DEVELOPMENT DETERMINATION PANEL MEETING

WEDNESDAY 23 AUGUST 2023

ITEM 3.1	REV2023/0015 - 175 FOREST WAY BELROSE - EARTHWORKS AND CONSTRUCTION OF A RETAINING WALL
REPORTING MANAGER	Steve Findlay
TRIM FILE REF	2023/504436
ATTACHMENTS	1 ↓ Assessment Report 2 ↓ Site Plan and Elevation

Application Number:	REV2023/0015
Assessment Officer:	Kye Miles
Land to be developed (Address):	Lot 11 DP 737255, 175 Forest Way BELROSE
Proposed Development:	Earthworks and construction of a retaining wall
Locality :	B2 Oxford Falls Valley under WLEP 2000
Category:	Category 2
Consent Authority:	Northern Beaches Council
Determination Level	Development Determination Panel
Land and Environment Court Action:	No
Owner:	P Langenhoven, L R Langenhoven
Applicant:	Cadence & Co Pty Ltd
Application Lodged:	29/06/2023
Notified:	06/07/2023 to 20/07/2023
Submissions:	1
Recommendation:	Approval
Estimated Cost of Works:	\$885,910

Figure 2 – Extent of Side setback breach to northern boundary

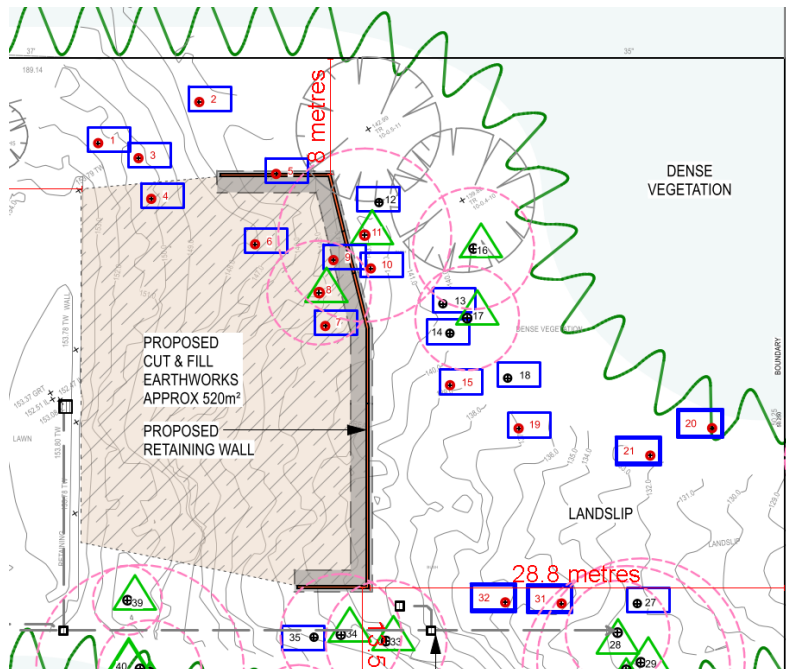
The proposed retaining wall results in a setback of 8.0 metres to the northern boundary, resulting in a variation of 20% (2.0 metres). See Figure 2 below.

Figure 1 - Building Height non-compliance

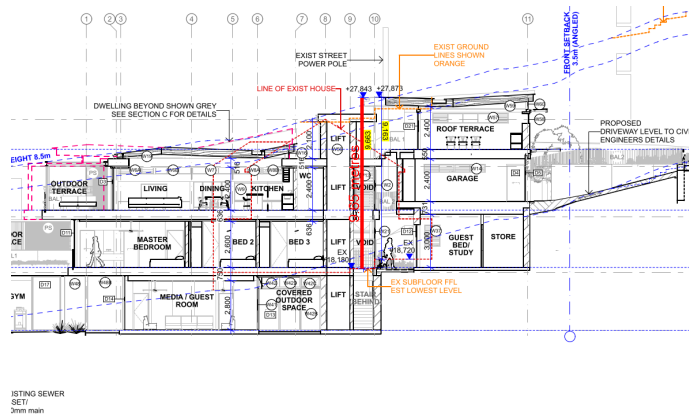
Development standard:	Height of buildings
Requirement:	8.5m
Proposed:	8m - 9.663m
Percentage variation to requirement:	13.68%

Image 1 - Eastern elevation building envelope non-compliance

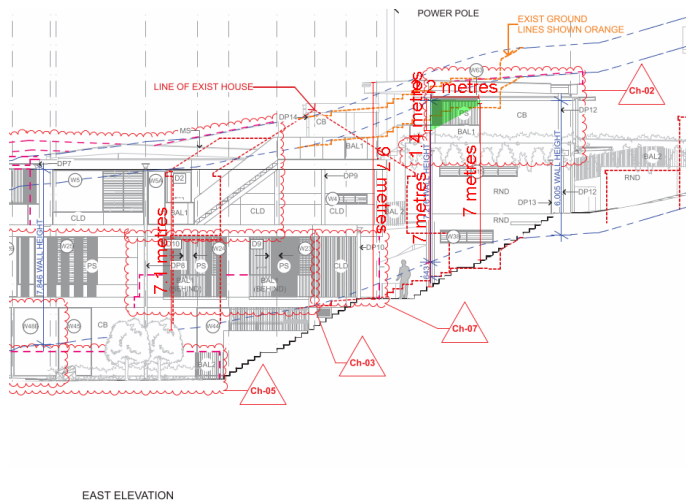
The proposal sits outside of the building envelope on the eastern facade as depicted in image 1. The eastern elevations obtains an encroachment of 0m - 1.4m in vertical height for a horizontal length of 2.2 metres, resulting in a maximum variation of 28%.

Figure 9: Tree identification map showing Tree 7 and structural root zone outlined in red.
Source: Hugh the Arborist. 29 March 2023

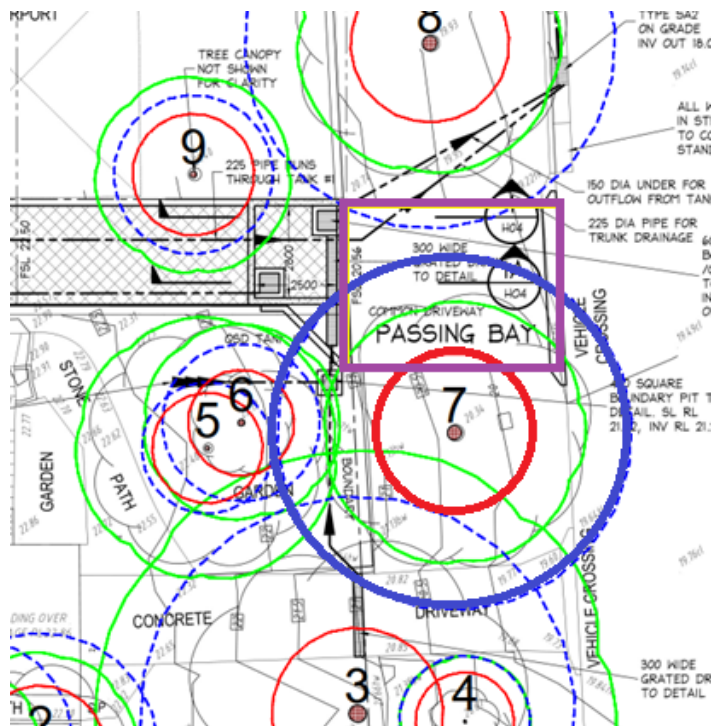
Trees 10 and 11 are identified as exempt species and do not require development consent for removal. Tree 7 is identified in **Figure 9** below, with the red indicating the structural root zone (SRZ), the blue the tree protection zone (TPZ) and the purple delineates the passing bay. The development will result in an encroachment of the SRZ.

Figure 11: Tree Location Plan of Lots 3, 4 and 5. Green identified tree crown, TPZ shown in blue and red is SRZ.

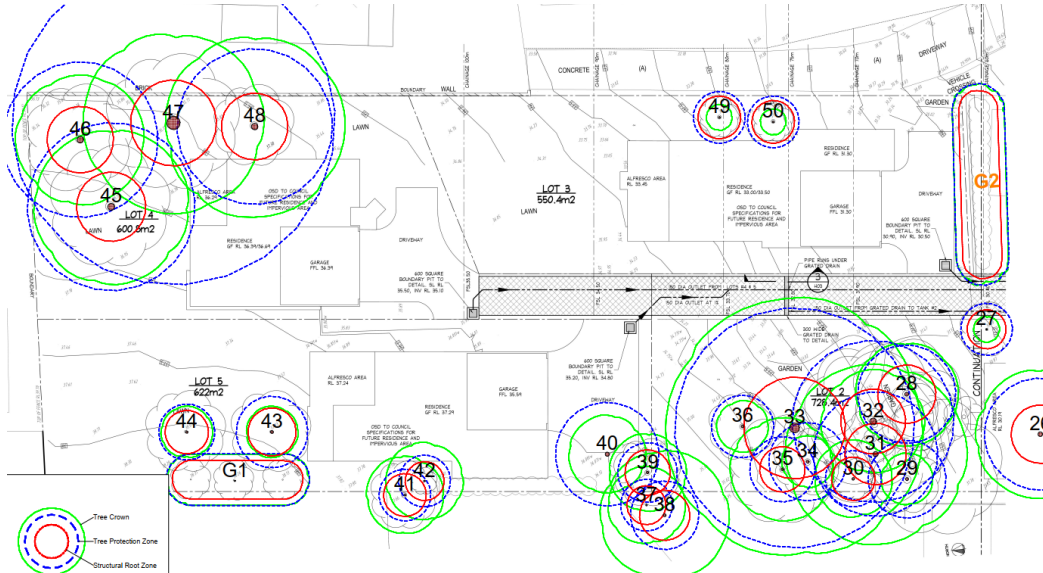
The AIA includes plans of the existing site plan and stormwater plans showing the TPZ and SRZ of trees on site. The trees on site, and their relationship with the future building envelopes anticipated for Lots 3, 4 and 5, is shown in **Figure 11**. Lot 1 and 2 is shown in **Figure 12**.

The proposal does not preserve the amenity of the area through the preservation of trees and other vegetation.

Figure 14: Concept plan for development of Lot 3. Existing dwelling at 40 Lakeside Parade. The red indicates windows and the blue is the front door.

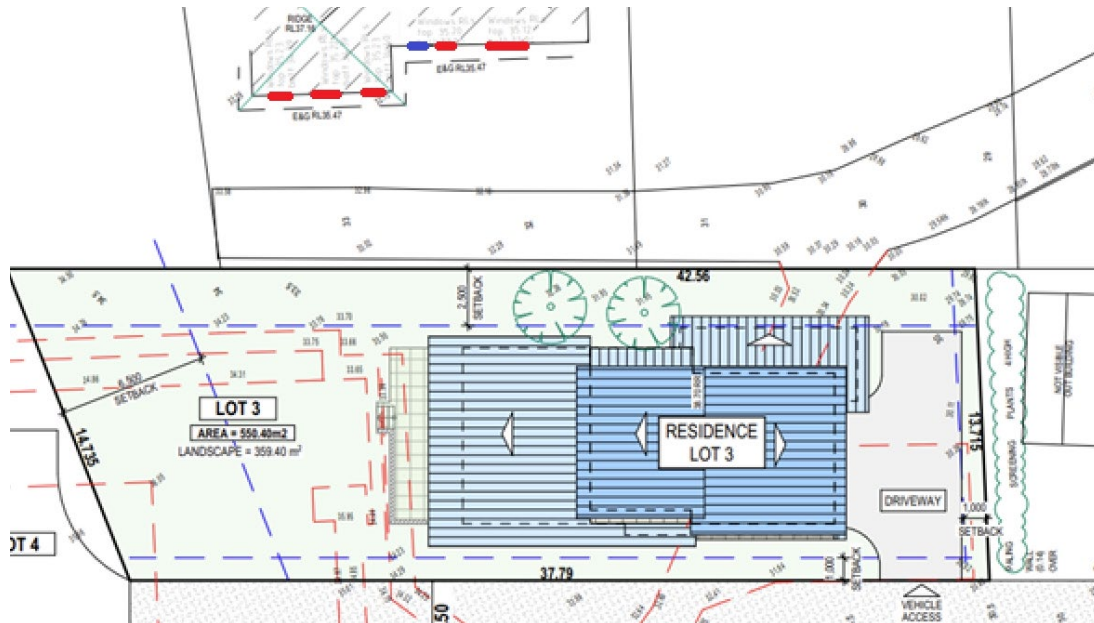
A letter was issued to the Applicant and requested concept plans for the development of the proposed allotments be submitted. The Applicant provided a concept design for Lot 3. The siting of the concept dwelling in relation to the existing dwelling at 40 Lakeside Parade is shown in **Figure 14**.

The existing floor level of 40 Lakeview Parade is approximately RL33.19. The sightlines available from the dwelling would therefore be at a height of RL34.69. The outlook from the dwelling, would be impacted by a dwelling in the position shown on the concept plans.

Figure: 19 Proposed subdivision showing accessway outlined in red.
Source: SDG, 28 March 2023 (CPS markup)

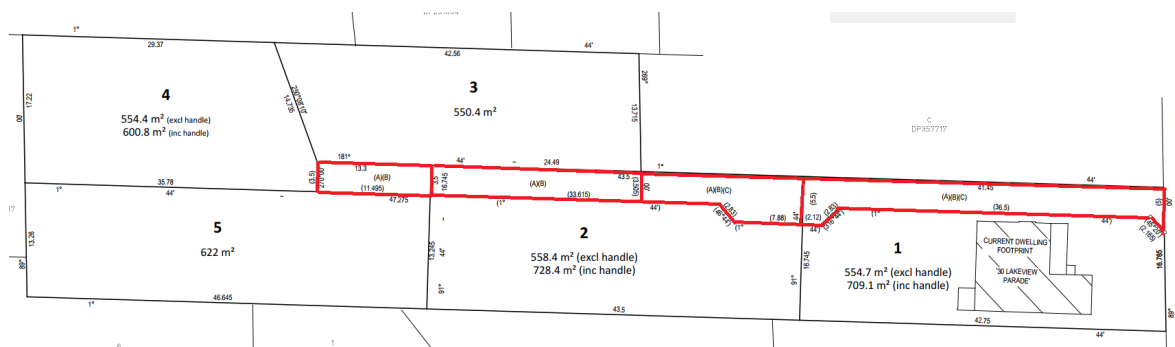
The subdivision proposed as a result of these dimensional variations suggest an overdevelopment of the site.

Figure 21: Tree Location Plan. Green identified tree crown, TPZ shown in blue and red is SRZ.
Source: Hugh the Arborist, 29 March 2023

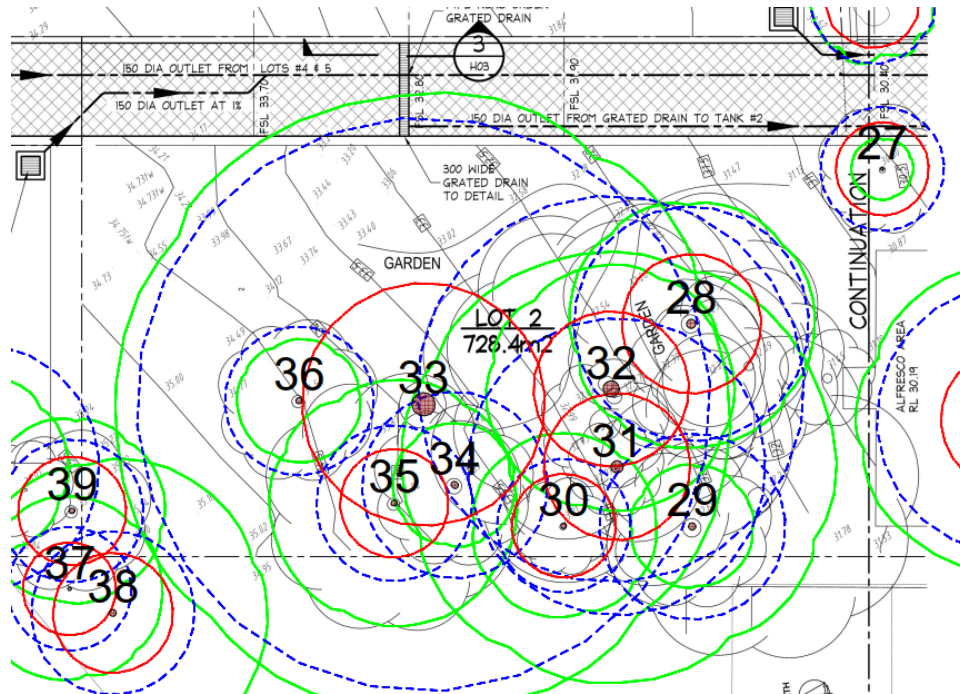
The northern portion of the site contains significant vegetation (Trees 31, 32, 33 and 36) which are identified for retention (**Figure 21**). The significant vegetation results in the building envelope being restricted to the southeastern corner of the allotment.

Figure 23: Concept plan of siting of development on proposed Lot 2
Source: JJ Drafting, March 2023

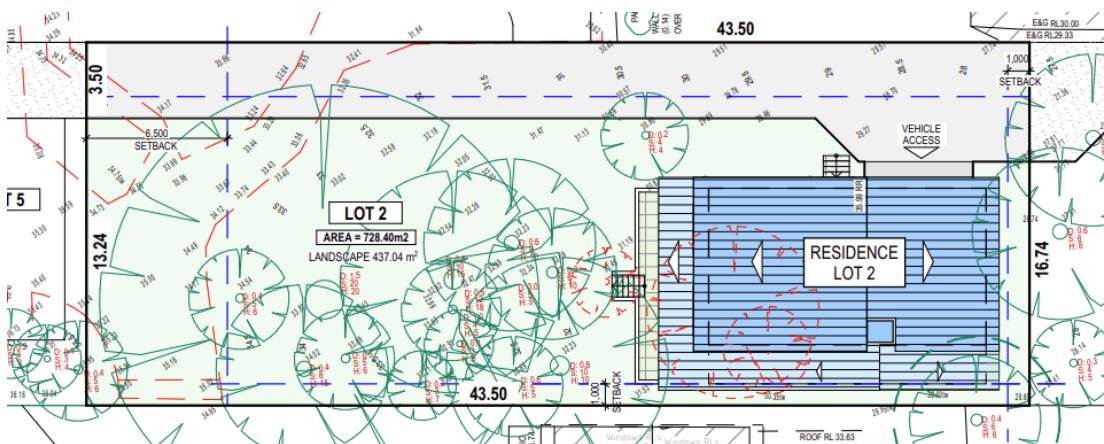
Despite these constraints, the Applicant submitted concept plans at the request of Council to demonstrate how the site can be developed in accordance with PDCP (**Figure 23**).

Figure 24: Concept dwelling for proposed Lot 3
Source: JJ Drafting, March 2023

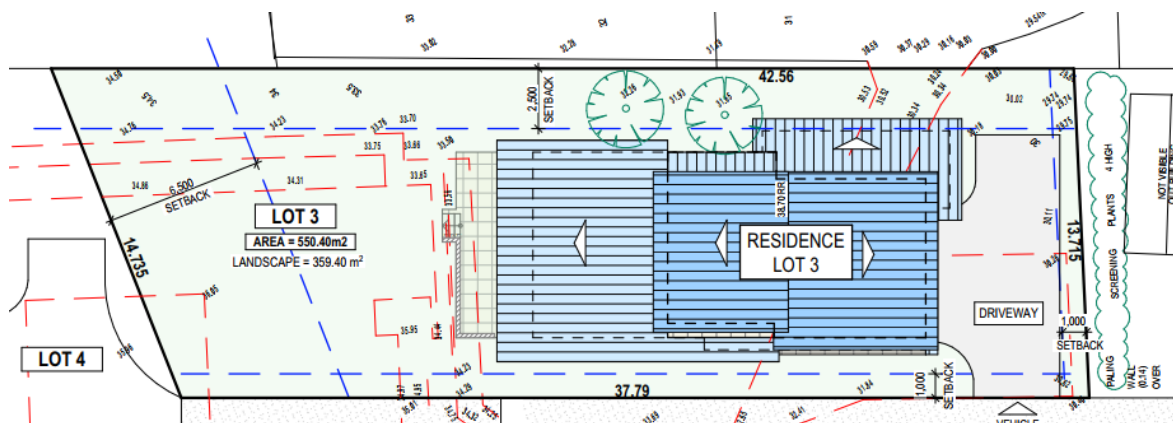
The concept design (**Figure 24**) sites the dwelling towards the southern boundary, and locates the driveway and turning bay within the front setback. The driveway is setback 1m from the southern boundary.

The lot fails to comply with the minimum width and front setback controls, and does not provide for the required 60% landscaped area controls contained with the PDCP. The front setback is not sufficient to accommodate the required two canopy trees within the front setback. In this circumstance, support for these non-compliances is not justifiable.

Figure 25: TPZ and SRZ of significant vegetation location on Lot 4 with concept dwelling shown.
Source: Hugh the Arborist, 29 March 2023

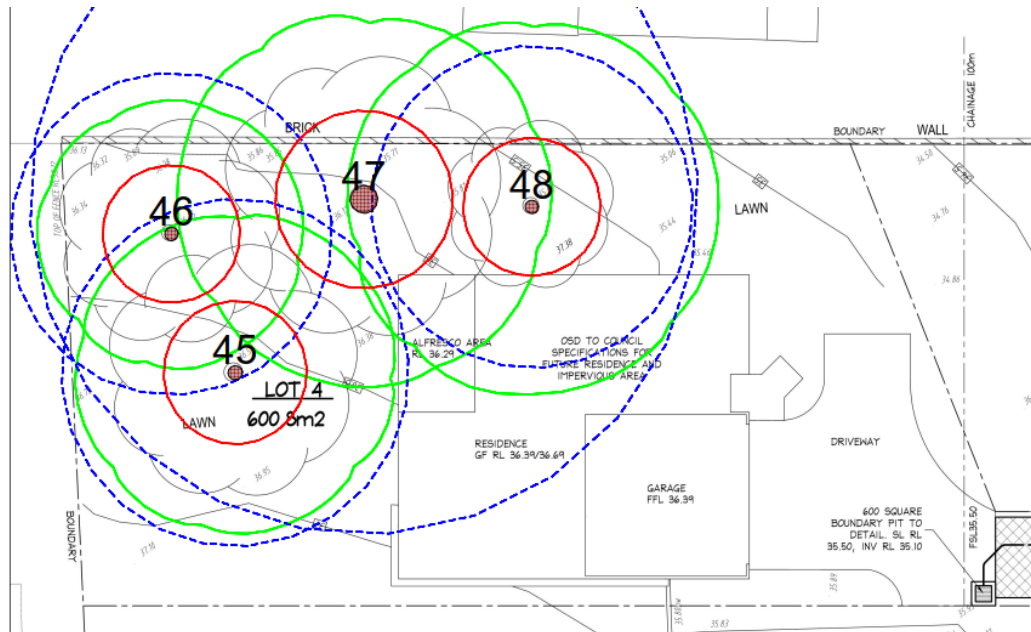
Lot 4 contains significant vegetation to the northeastern corner of the site (**Figure 25**). The vegetation includes 3 x *Melaleuca quinquenervia* (Tree 45, 47 and 48) and 1 x *Araucaria heterophylla* (Tree 46).

The significant vegetation creates a constraint on the allotment. The Arborist report recommends the need for specific requirements for Trees 47 and 48 as the concept plan represents a major encroachment of the TPZ.

Figure 26: Concept plan for Lot 4
Source: JJ Drafting, March 2023

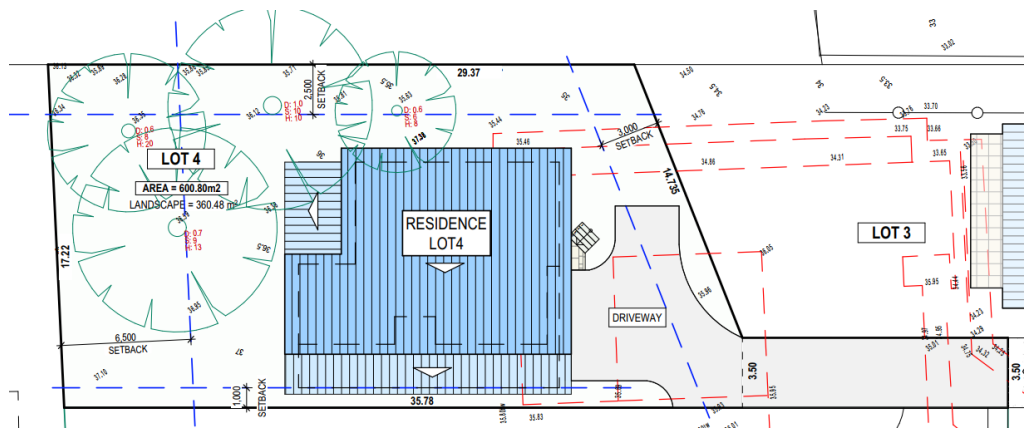
The Applicant has submitted a concept design for the lot (**Figure 26**). The concept plan does not demonstrate the significant vegetation can be retained. It cannot be said that the building would achieve the desired future character of the area and does not overly impact on the environment.

Figure 27: Concept plan for Lot 5
Source: JJ Drafting, March 2023

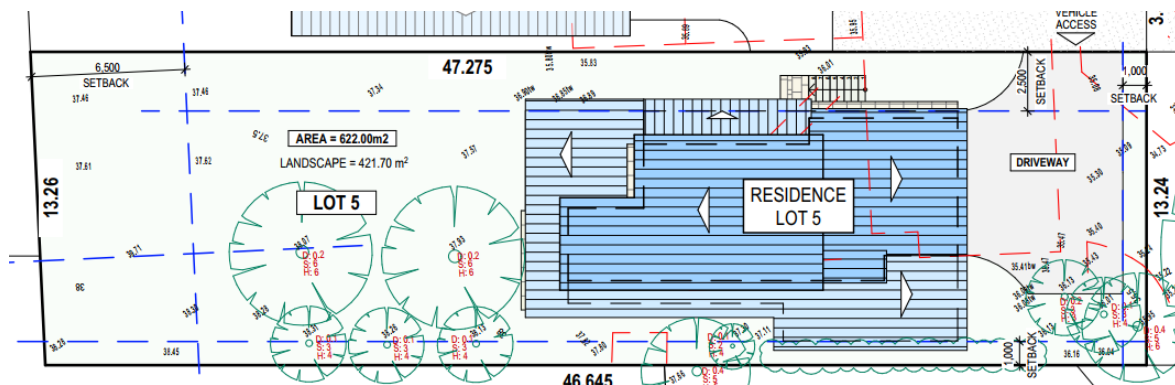
The concept design (**Figure 27**) positions the dwelling towards the southern boundary and locates the driveway with the turning bay within the front setback. The driveway is setback 1m from the southern boundary.

Figure 29: Proposed driveway and turning area within Lot 3 outlined in red.
Source: JJ Drafting, March 2023 (CPS markup)

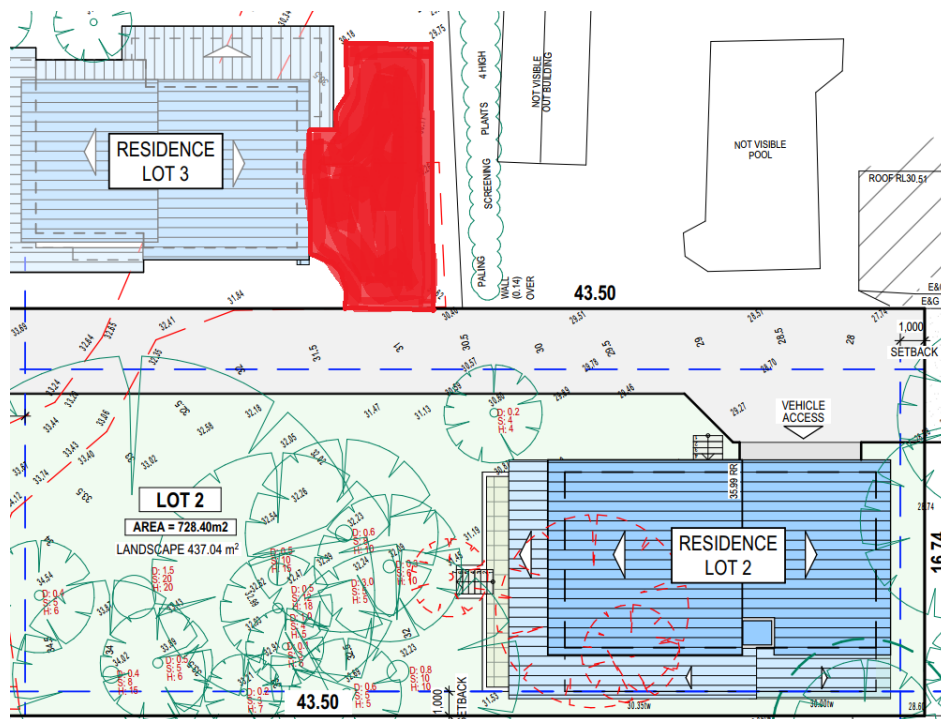
This arrangement provides for a further constraint of the proposed allotments and results in reduced areas for landscaping and separation between neighbouring sites.
